DESIGN & ACCESS STATEMENT

Wedderburn Road

9 Wedderburn Road London NW3 5QS

Date: 30.07.2024 Revision: A

PROPOSED REAR ELEVATION EXTRACT

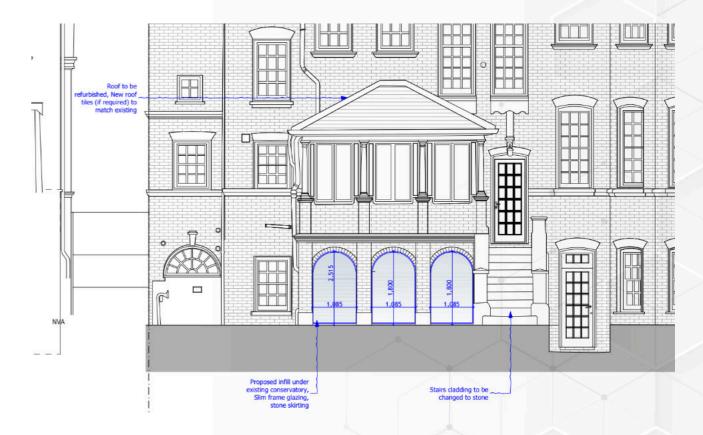
The irreversible loss of existing historic sash windows and their brick aprons in the LGF undercroft is deemed unacceptable.

Infilling the open arches in the undercroft with arched, small panelled windows and brick aprons, is deemed unacceptable as this would be too solid and detract from the character of this element of the building. An alternative low impact option could be considered, involving the infilling of the arched openings with full-height minimalist glazing, so that the original architecture still reads.

The scheme has been amended, and the historic windows are retained and designed into the scheme.

The scheme incorporated the above recommendation, with the arches closed off with glass infills. This ensures the enhancement of functionality is achieved, whilst the perception of the original architecture remains clear and unobstructed.
